Project/Property Address or Location: 1041 North Hamilton Road		Project Name/Business Name (if applicable): The Shops at Oberer's Crossing	
Parcel ID No.(s): 025-009953	Current Zoning: PCC	Total Acreage: 5.19	
Project Description: Neighborhood service retail, office and restaurant in three buildings located at the southwest corner of Beecher Road and North Hamilton Road.			
APPLICANT Name (primary contact) -do not use a business name: Academy Development Limited Partnership		Applicant Address: 107 S. High Street, Suite 300, Columbus, OH 43215	
Applicant E-mail: jsugar@arshot.com		Applicant Phone No.: 614-463-9730	
BUSINESS Name (if applicable):			
ATTORNEY/AGENT Name: Glen A. Dugger, Smith & Hale LLC		Attorney/Agent Address: 37 W. Broad Street, Columbus, OH 43215	
Attorney/Agent E-Mail: gdugger@smithandhale.com		Attorney/Agent Phone No.: 614-221-4255	
ADDITIONAL CONTACTS (please list all applicable contacts)

THE SHOPS AT OBERER'S CROSSING

Project 1041 N. Hamilton Rd. Final Development Plan Responses to comments dated December 18, 2017

C101

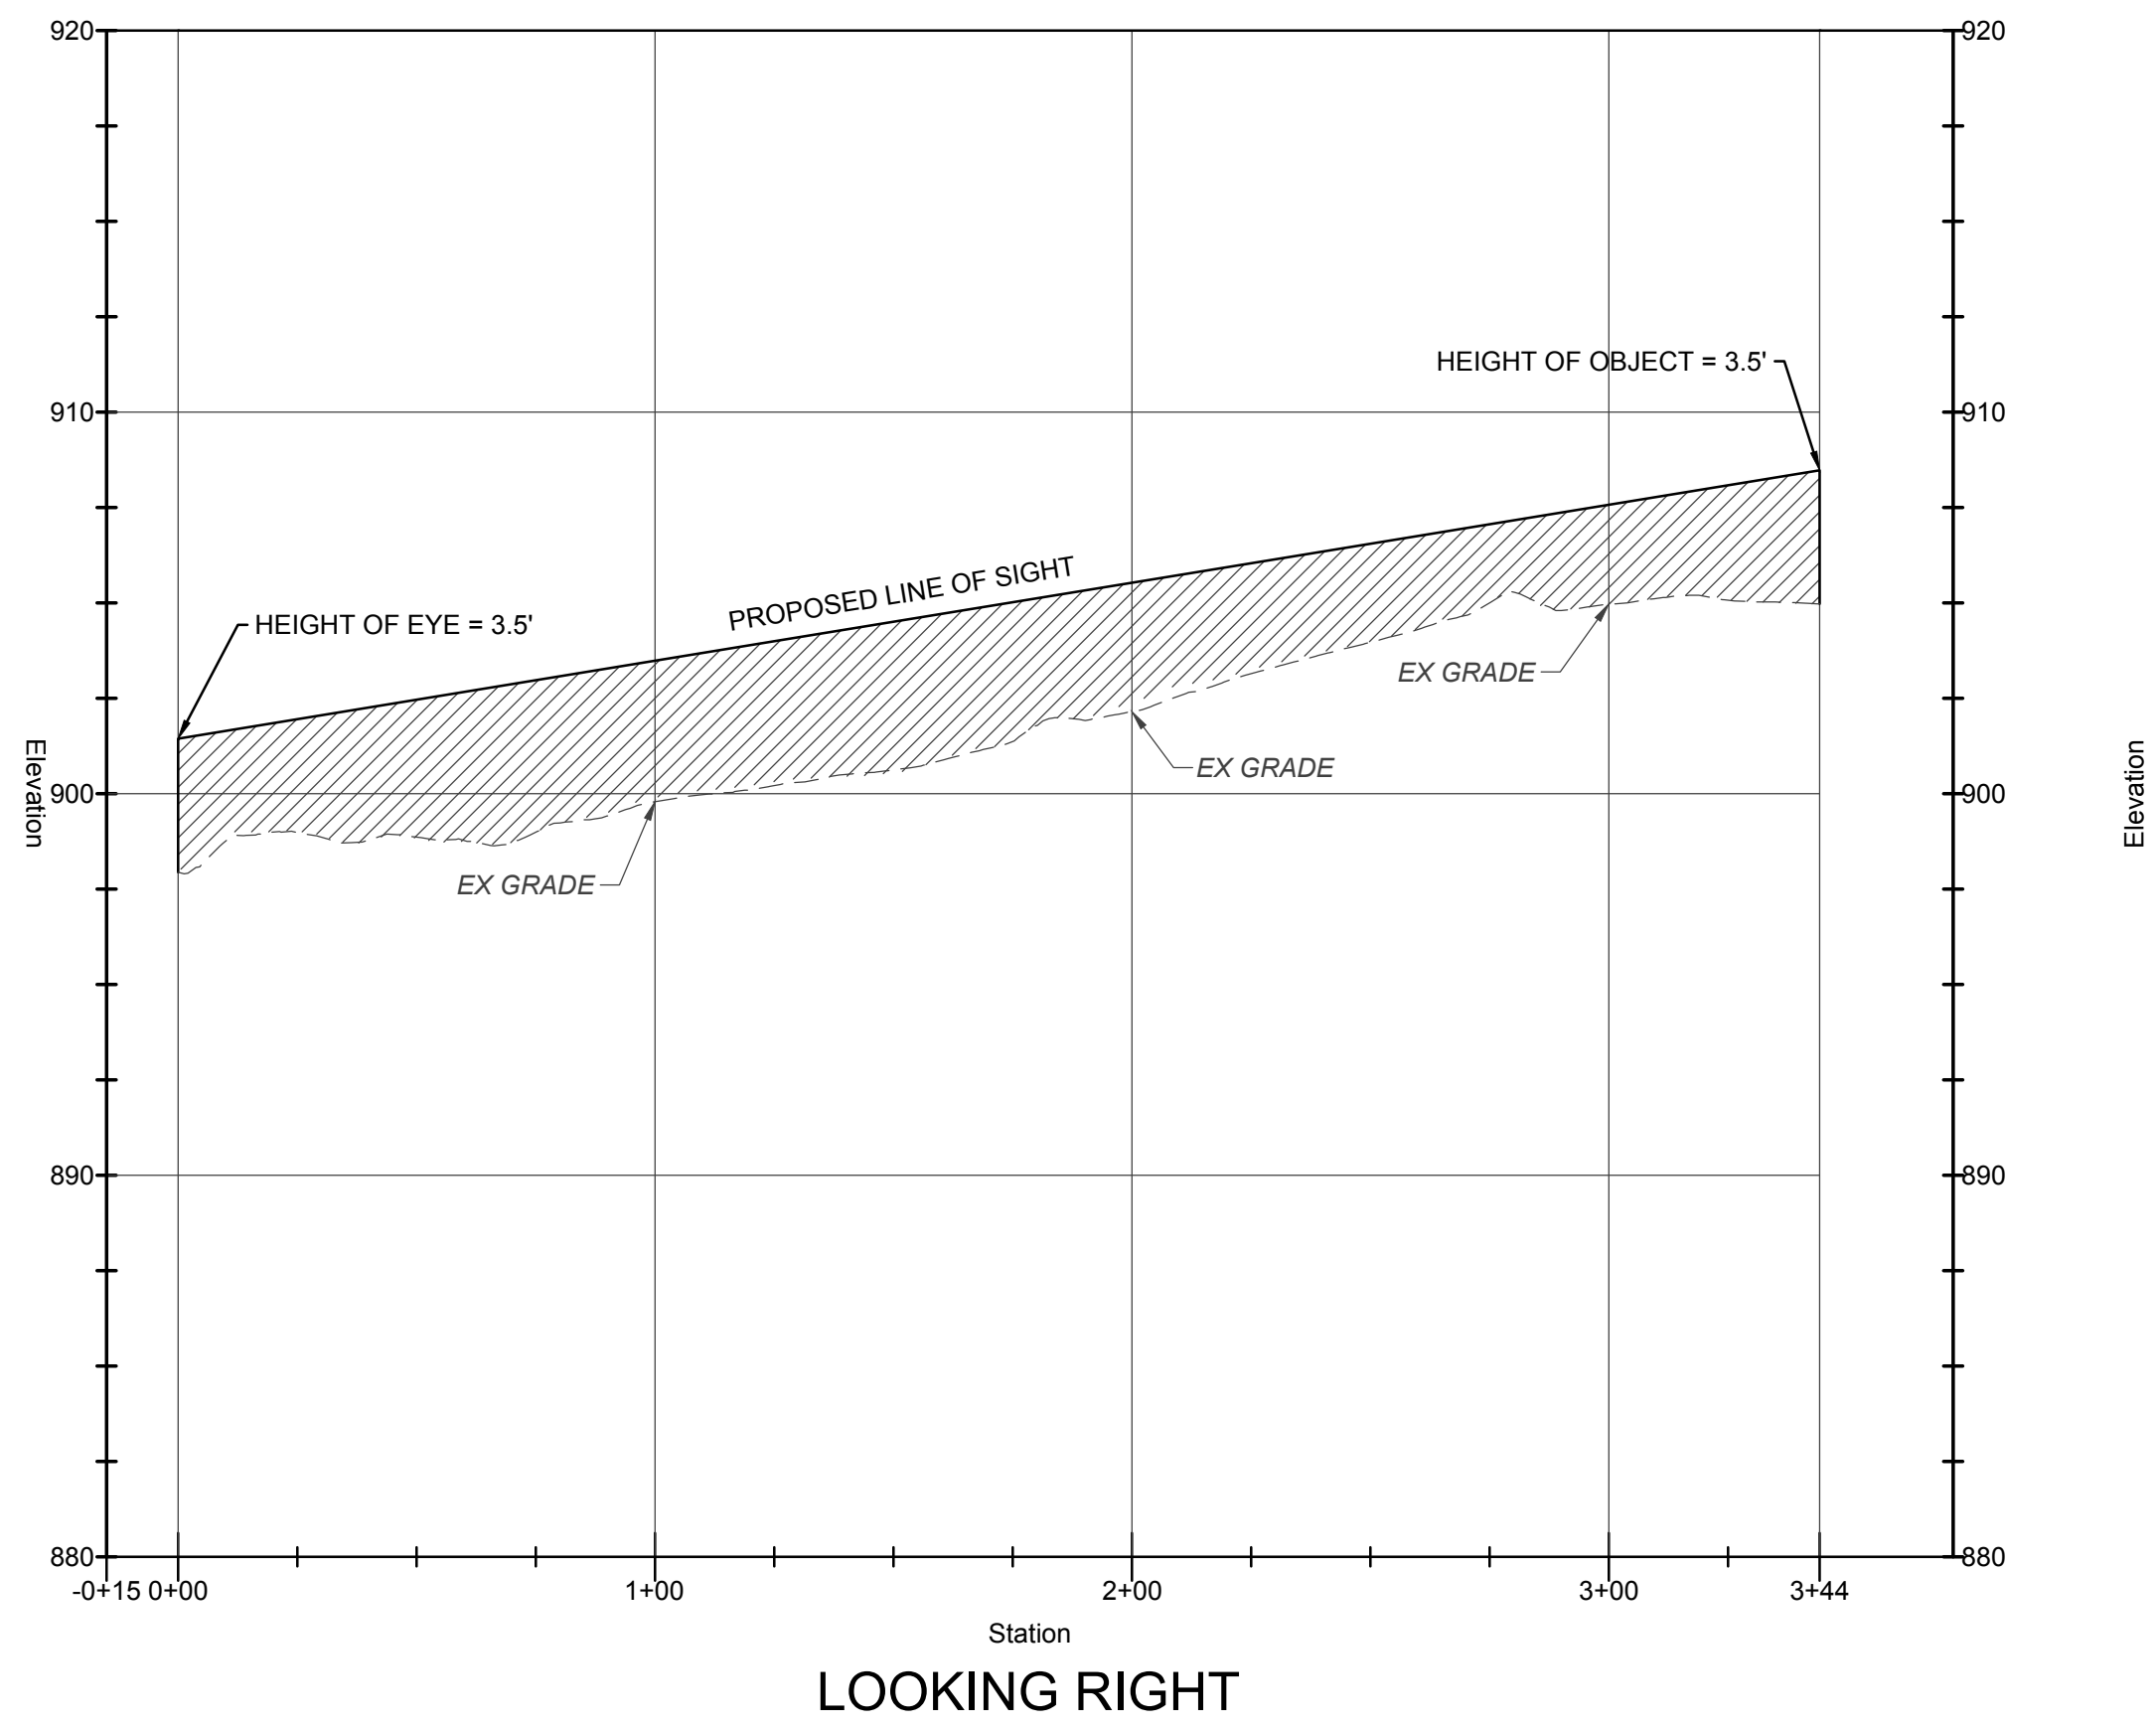
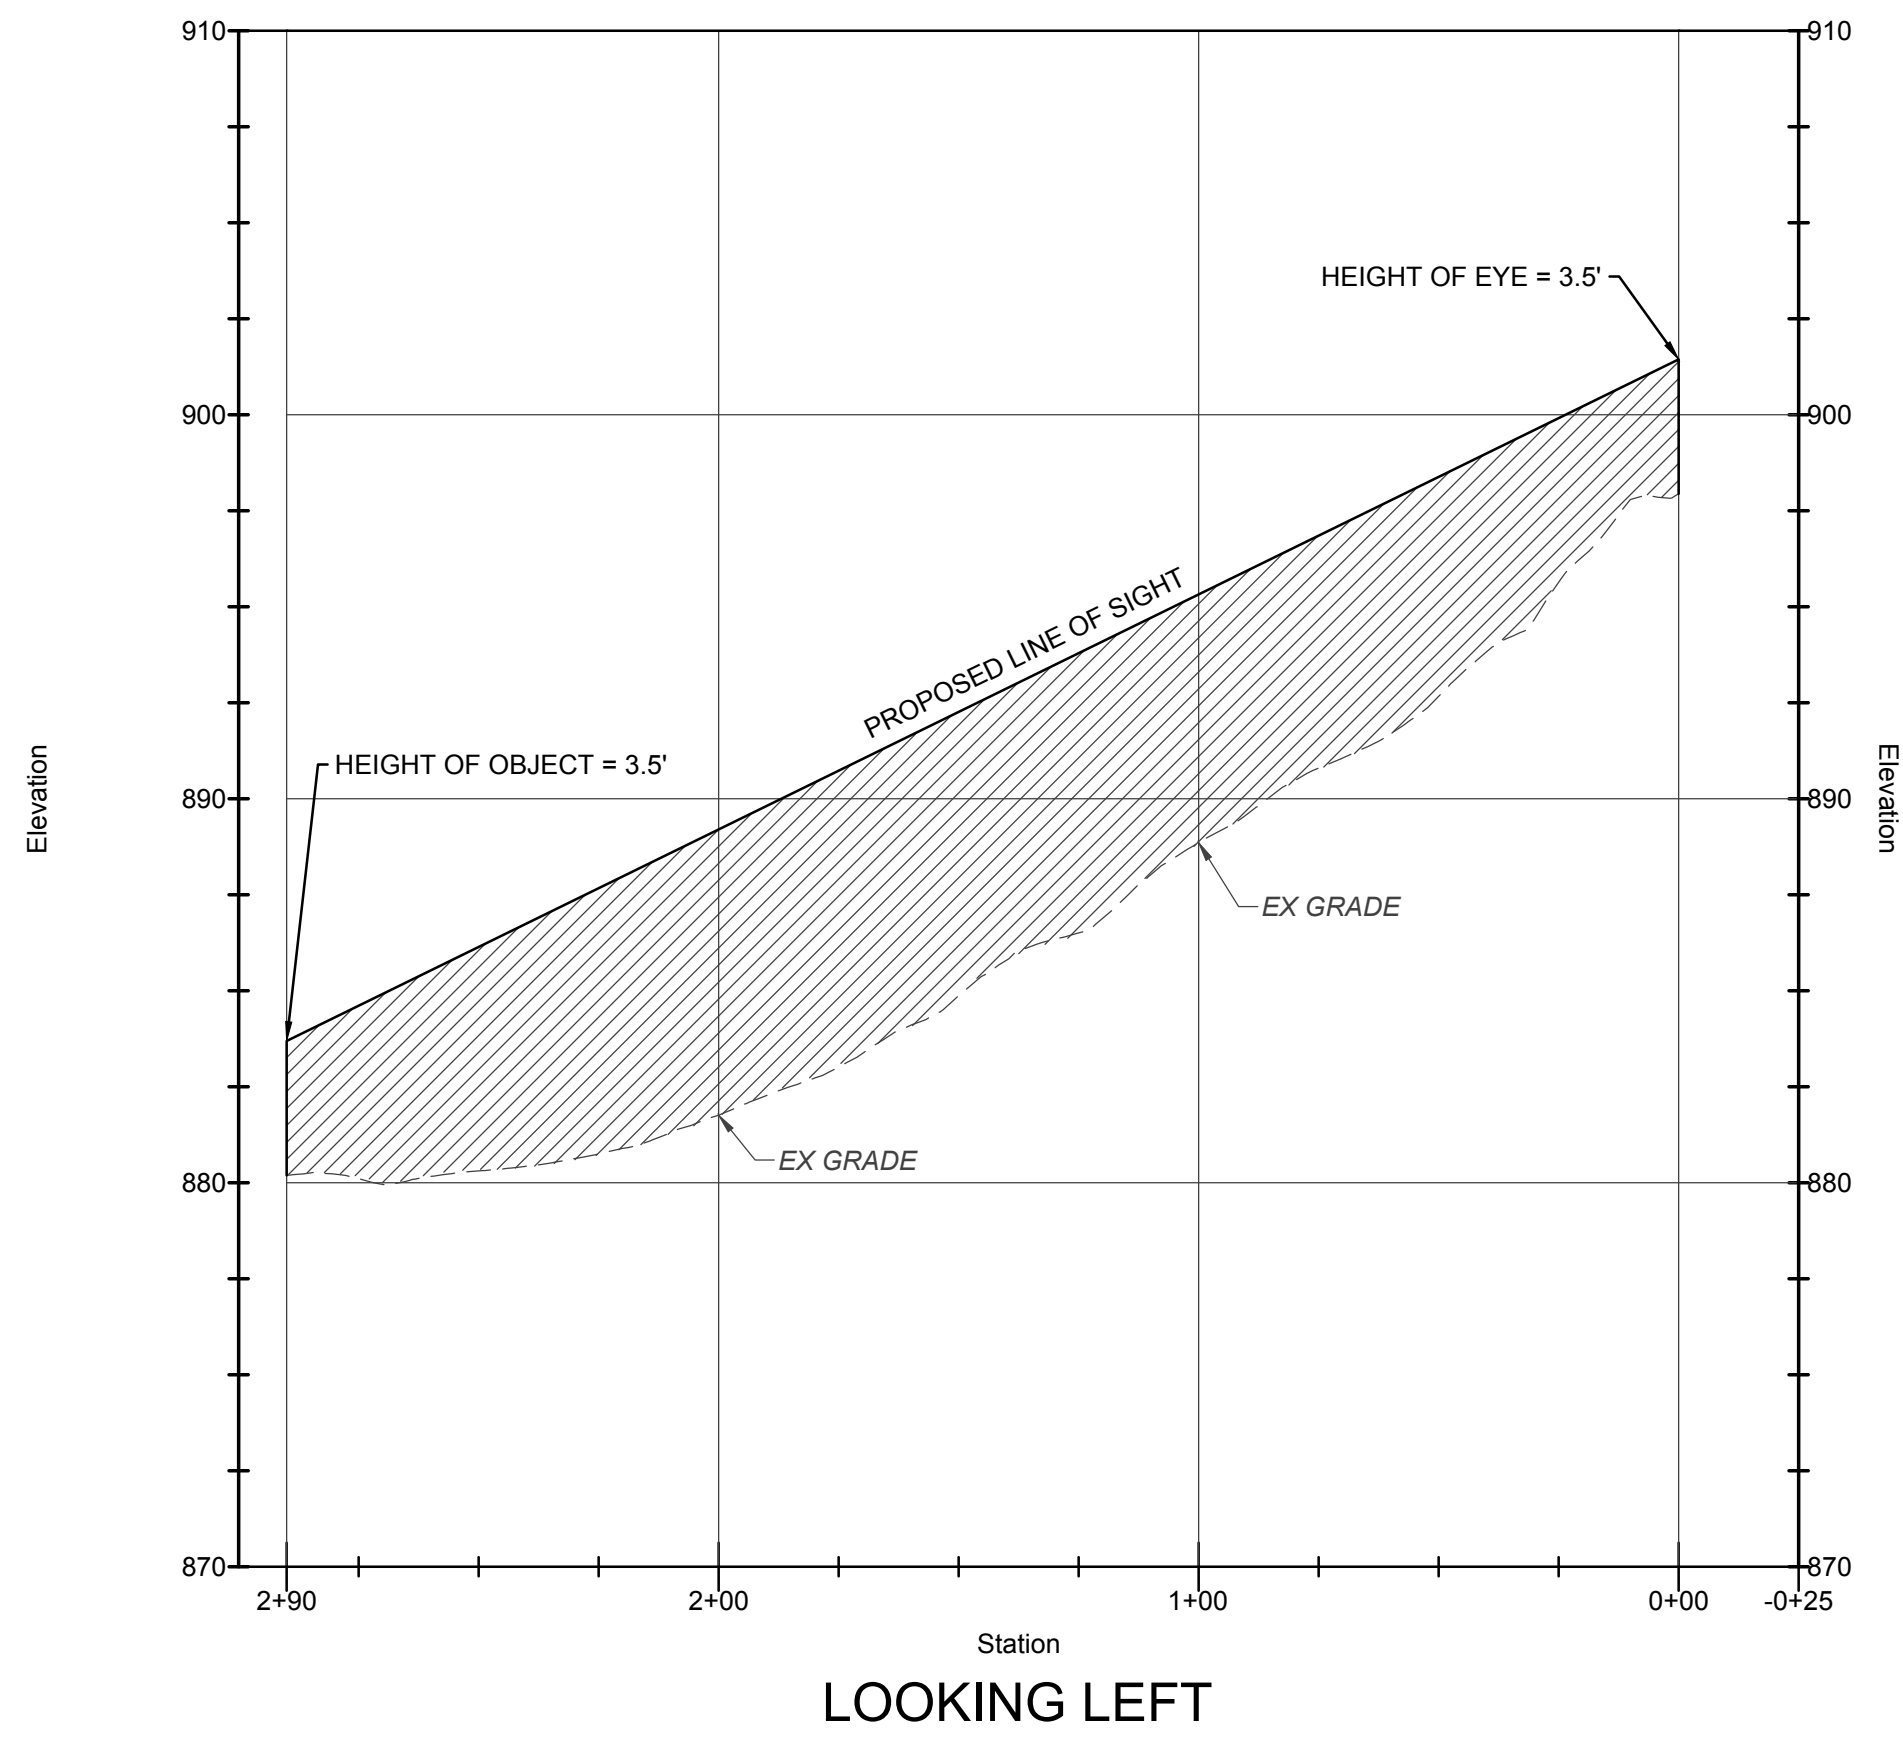
- (e) Please verify that the adequate intersection sight distance is provided for the proposed access location on Beecher Road.
- (f) Sidewalk and or multi-use trail shall be constructed, re-constructed and or maintained along the entire frontage of the development.

- (a) Complete. The traffic impact study has been updated and submitted.
- (b-d) Complete. The FDP shows one full-service access on Beecher Rd. and one right-in/out access on Hamilton Rd. A minor widening of Beecher Rd. is also shown, as necessary to accommodate a future left turn lane.
- (e) Complete. Adequate intersection sight distance is provided for Beecher Rd. access.
- (f) Complete. Sidewalk and multi-use trail will be maintained and/or constructed along frontage as shown on FDP.
